UNITED STATES PATENT AND TRADEMARK OFFICE

APPLICATION NO.	FILING DATE	FIRST NAMED INVENTOR	ATTORNEY DOCKET NO.	CONFIRMATION NO.
10/051,486	01/18/2002	John D. Phillips	24457B	1435
22889	7590	11/05/2004	EXAMINER	
OWENS CORNING 2790 COLUMBUS ROAD GRANVILLE, OH 43023			A, PHI DIEU TRAN	
		ART UNIT		PAPER NUMBER
				3637

Office Action Summary	Application No.	Applicant(s)	
	10/051,486	PHILLIPS, JOHN D.	
	Examiner	Art Unit	
	Phi D A	3637	My

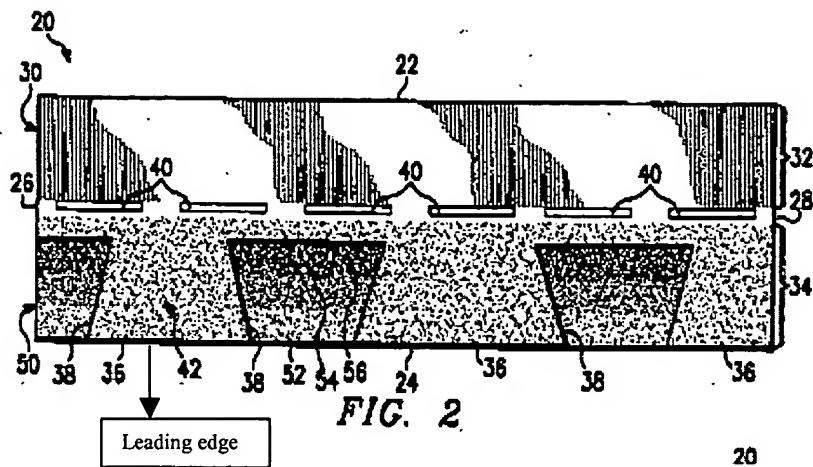
2. Claims 1-6 are rejected under 35 U.S.C. 103(a) as being unpatentable over Weaver et al (5666776) in view of Hannah et al (D336347) and Corbin et al (4274243).

Weaver et al (below) shows a laminated roofing shingle having an overlay(20) having an underside and a plurality of spaced apart tabs (36), each one of the tabs (36) having a leading edge (see below), the tabs defining openings adjacent the tabs, an underlay (50) attached to the underside of the overlay to cooperatively form the laminated roofing shingle, the underlay having a leading edge (52), a second shadow line (56), a remaining portion between the leading edge of the underlay and the second shadow line, the leading edge of the underlay generally co-aligning with the leading edge of the tabs, the underlay having a portion exposed through the openings defined adjacent the tabs, a layer of granules disposed on the underlay in a manner whereby the second shadow line of the underlay is substantially darker than the granules on the remaining portion of the underlay, said overlay and said underlay are each formed from a base material comprising fiberglass mat that has been coated with asphalt, the granules on the second shadow line being black granules (col 4 line 5).

Weaver et al does not show the tab having a first shadow line and a remaining portion, a layer of granules disposed on the first shadow line of the tabs and on the remaining portion of the tabs in a manner whereby the first shadow line of the tabs being substantially darker in color than the remaining portion of the tabs, the granules on the first shadow line being black granules.

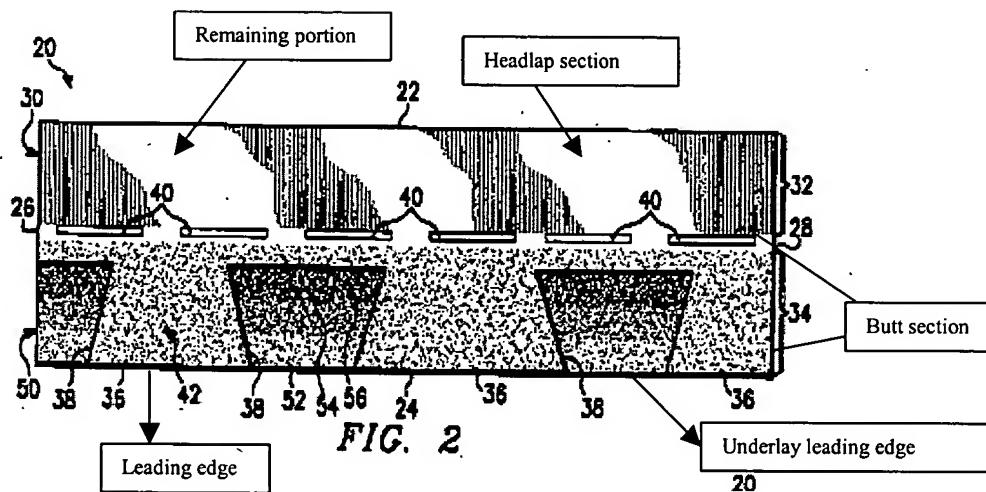
Weaver et al (below) shows a laminated roofing shingle comprising an overlay having an underside, headlap section (sections comprise of 30 or 32), a plurality of spaced apart tabs (36) extending from the headlap section, the headlap section having a leading edge (the leading edge of 30 or 32), each one of the tabs having a leading edge (36), an outer surface, an underlay (50) attached to an underside of the overlay to cooperatively form the laminated roofing shingle, the underlay having an outer surface, a leading edge, a trailing edge, a second shadow line (56) and a remaining portion (54) between the leading edge of the underlay and the second shadow line, the tabs and the leading edge of the headlap section defining openings, the leading edge of the underlay generally co-aligning with the leading edge of the tabs, the second shadow line and the remaining portion of the underlay being on the outer surface of the underlay, the second shadow line extending from the trailing edge of the underlay to the remaining portion of the underlay, the

underlay having a portion exposed through the openings defined by the tabs and the leading edge of the headlap section, the second shadow line being exposed through the opening and adjacent the leading edge of the headlap section, a layer of granules disposed on the underlay in a manner whereby the second shadow line (56) is substantially darker than the granules on the remaining portion of the underlay, the overlay and the underlay each being formed from a base material comprising a fiberglass mat that has been coated with asphalt, the granules on the granules on the second shadow line being black, a second shadow line (56).

Weaver et al does not show the tab having a first shadow line and a remaining portion, said first shadow line and the remaining portion being on the outer surface of the tabs, the first shadow line extending from the leading edge of the tabs to the remaining portion of the tabs, a layer of granules disposed on the first shadow line of the tabs and on the remaining portion of the tabs in a manner whereby the first shadow line of the tabs is substantially darker in color than the granules on the remaining portion of the tabs.

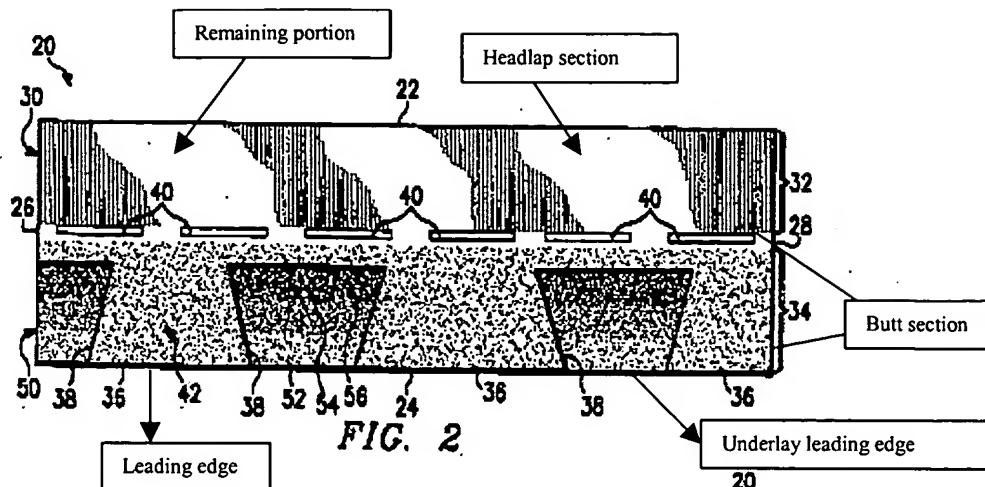
Weaver et al (below) shows a laminated roofing shingle having a headlap section and a butt section (the section starting below 30 or 32) comprising an overlay having a tab (36), the tab having an outer surface with a trailing edge adjacent the headlap section and a leading edge (36) spaced from the trailing edge, the tab having a width, an underlay (50) attached to an underside of the overlay, the underlay having an outer surface, the underlay outer surface positioned adjacent the tab with a trailing edge (26) adjacent the headlap section, a leading edge spaced from the trailing edge and first colored granules (42) adhered to the outer surface of the tab adjacent the leading edge of the tab to produce a first colored portion, second colored granules (the part around the openings 40) adhered to the outer surface of the tab separated from the leading edge (36) of the tab by the first colored granules to produce a second colored portion that is different coloration or shade than the first colored portion, the second colored granules having a different coloration or shade than the first colored granules, third colored granules (56) adhered to the trailing edge of the outer surface of the underlay to provide a third colored portion, fourth color granules (52) adhered adjacent the leading edge of the outer surface of the underlay having different coloration or shade than the third colored granules, ,

the third colored granules (56) form a shadow line adjacent the trailing edge of the outer surface of the underlay, the third colored granules comprise darker granules than the fourth colored granules, the first and third colored granules comprise black colored granules, a second tab (the next tab), the second tab adjacent the outer surface of the underlay, the second tab having sixth colored granules (42) forming a shadow line adjacent a leading edge of the second tab.

Weaver et al does not show said first colored granules form a shadow line adjacent the leading edge of the tab across substantially the entire width of the tab, the first colored granules (42) comprise darker granules than the second colored granules, the first colored granules comprise black colored granules, the second tab having sixth colored granules (42) forming a shadow line adjacent a leading edge of the second tab.
